# PRELIMINARY DRAINAGE REPORT

## FALCON MEADOWS AT BENT GRASS

### Engineering Review

EPC Planning & Community  
Development Department

## INLET IN A SUMP OR SAG LOCATION

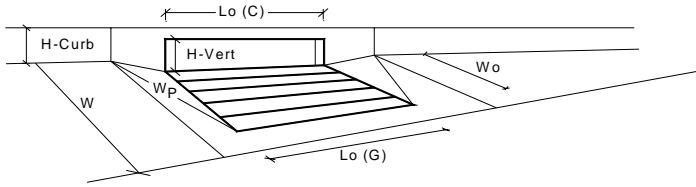
Not checked with this review. Provide all inlet calculations.
